Final Report

***Initial Observational Field Study of the Union Pacific Railroad (UPRR)
“Light Cannon” (LC) as a proposed “new” LED-based Color Vision Field
Test (LC CVFT) at UPRR SOSAN Railroad Yard, San Antonio, Texas on
10/1/2015***

25 January 2016

Figure 2. Renditions of UP wayside LED signal lights as seen by normal and severe red and green cone CVDs

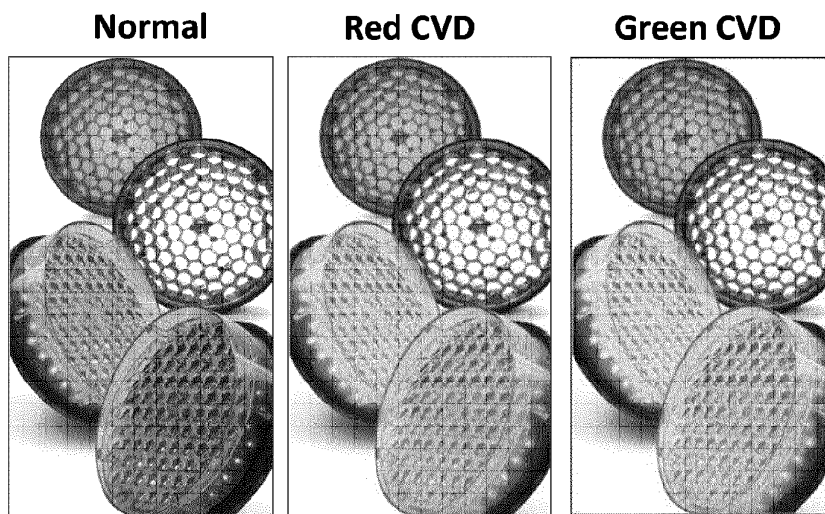
Figure 2 shows renderings of the UP LED signal lights as seen by CVN and CVD observers.³ While these renderings do not agree exactly with our quantitative predictions, they further emphasize the potential ambiguity for CVDs to accurately discriminate the LED signal lights.
